**STATE OF DELAWARE
EXECUTIVE DEPARTMENT
OFFICE OF STATE PLANNING COORDINATION**

RE: PLUS review – 2012-04-05; Walker Farm Estates

Thank you for meeting with State agency planners on April 24, 2012 to discuss the proposed plans for Walker Farm Estates project the to be located at 1080 Old Lancaster Pike and 5 Kings Grant Road near Hockessin.

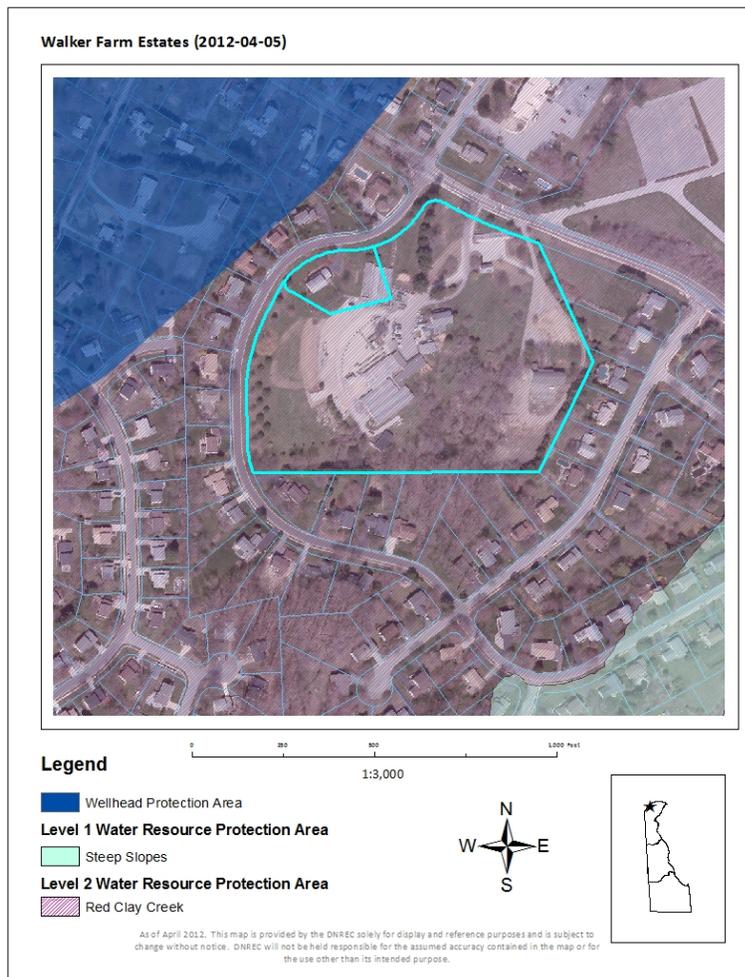
- The DNREC Ground-Water Protection Branch (GPB) has determined that it falls entirely within a Level 2 Water Resource Protection Areas for New Castle County (NCC). This area is in the Drinking Water Basin for Red Clay Creek (see map).

GPB recommends referring to NCC Unified Development Code for regulations regarding development in this critical area.

Figure 1: NRCS soil mapping in the immediate vicinity of the proposed project

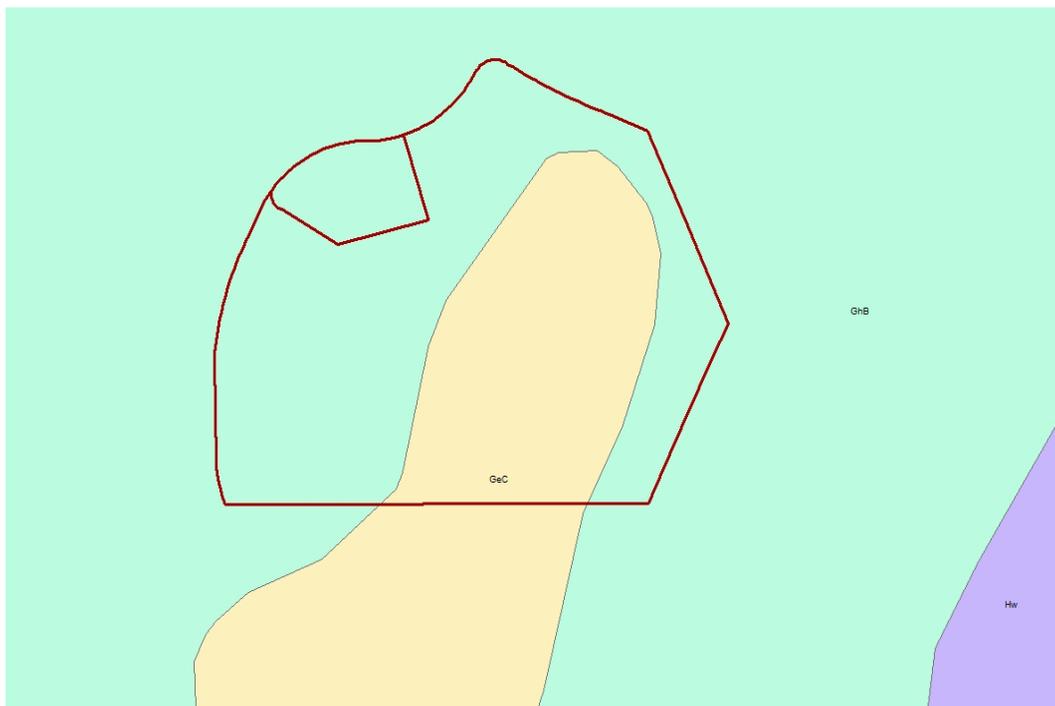
- The Glenelg (GeB; 3-8% slope) soil mapping unit is a well-drained upland soil mapping unit that, generally, has few limitations for development. In contrast, the Glenelg (GeC; 8-15% slope) soil mapping unit has significant limitations for development because of steeply sloping topography; especially where slopes on the landscape exceed 10%. We strongly recommend avoiding such areas. Building on steeply sloping topography may increase water runoff and flooding potentials.
